Change Bulletin

No: **CB015**

Description: Torque Bushing Assembly Upgrade

Tesco Corporation
6204 – 6A Street SE
Calgary, AB. T2H 2B7
Phone: (403) 692 5700
www.tescocorp.com

An example of these changes is shown on the torque bushing assembly for HCI/ECI (part 7970) on the next page. Refer to each part's specific drawing (as listed in the previous section) to observe the changes for the part in question.

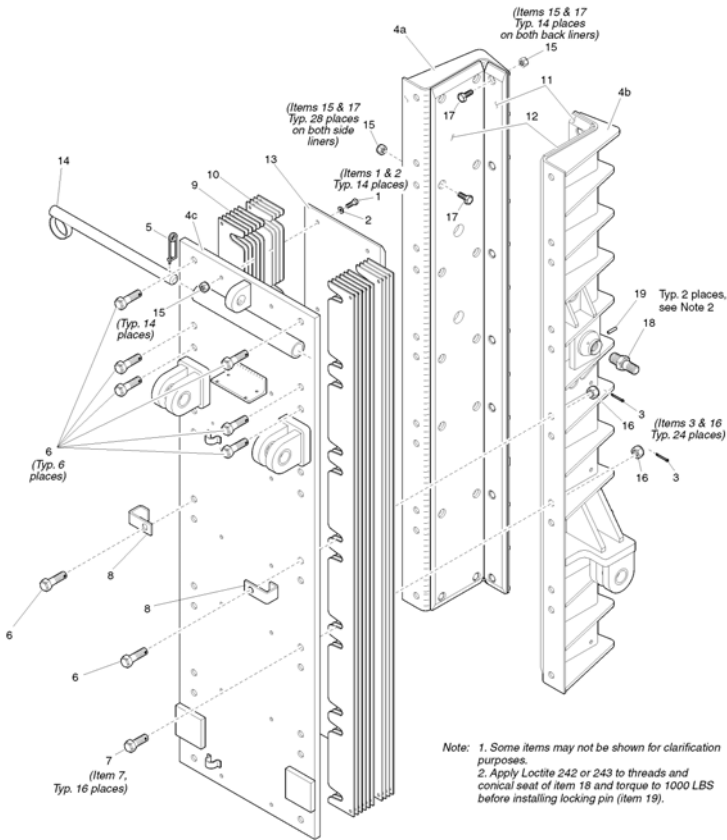
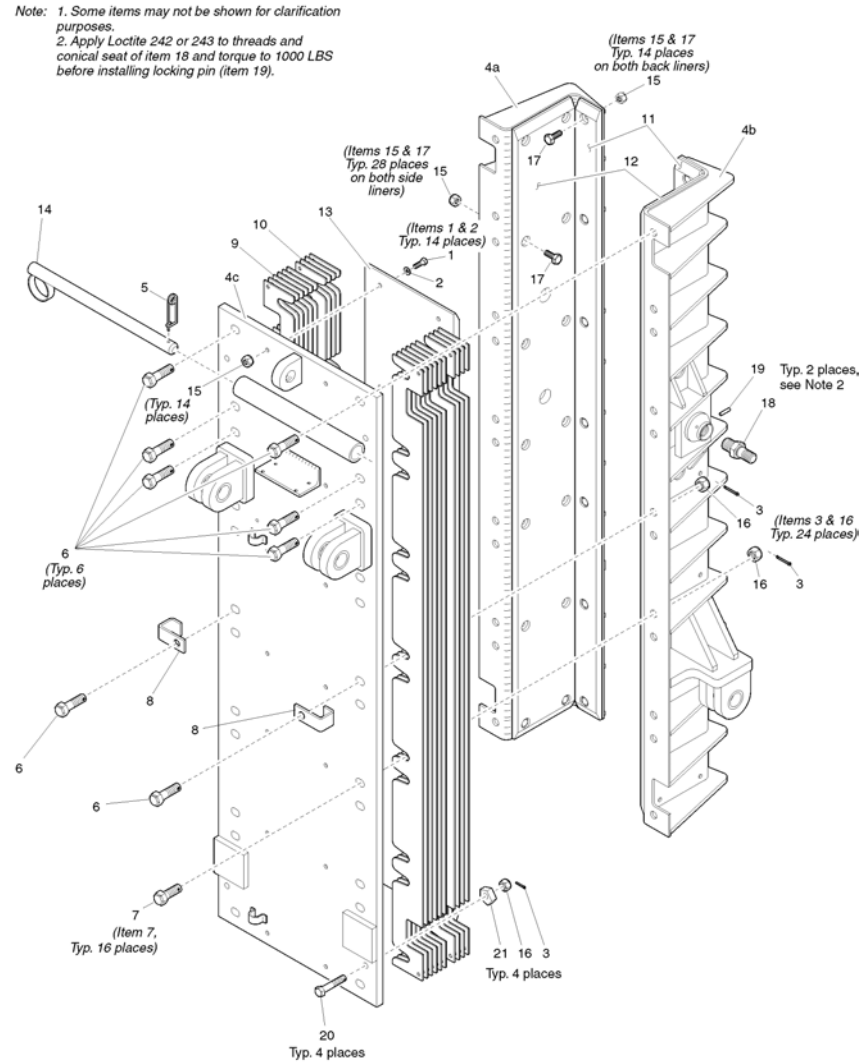
Earlier version:
 Note the bolting holes are round

Revised version showing the slotted side plate mounting holes, notched side plates, 5-sided adjuster nuts, notched extend frame shim plates. Accumulator mount modifications are not shown but are to clear the new 5-sided adjuster nuts.

- The mounting holes for the side plates have been slotted
- Dimensioning and GD&T scheme for the front plates has been revised
- A 5-sided adjuster nut has been added to the torque bushing assemblies
- The accumulator mounts and standard pin have been modified, and the frame pads have been extended to accommodate the adjuster nuts.
